Safety Recall Trucks

Clutch Pedal Safety Recall
CHU, CXU, GU

Clutch Pedal Safety Recall SC0355

(August 2011)

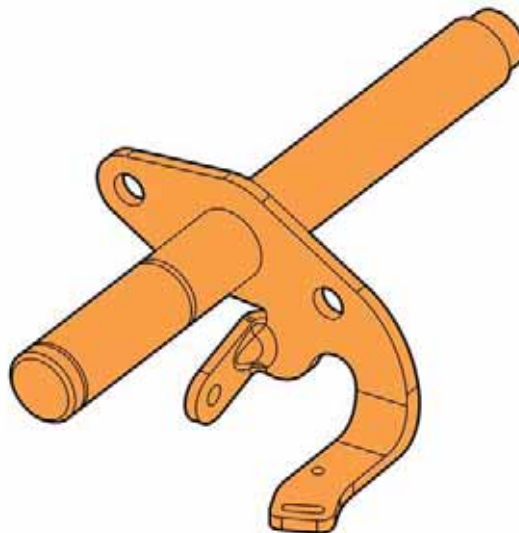
MACK has identified a potential safety related defect in the clutch pedal shaft assembly on CHU, CXU, and GU model trucks. These trucks may have been built or repaired with a clutch pedal shaft assembly containing improper welds. The improper weld is located between the clutch pedal stop flange bracket and the clutch pedal shaft. If the weld fails, the pedal's shaft may work its way loose and potentially cause the clutch pedal to fall to the floor which could result in a vehicle crash.

Clutch shaft and bracket assembly 82280756
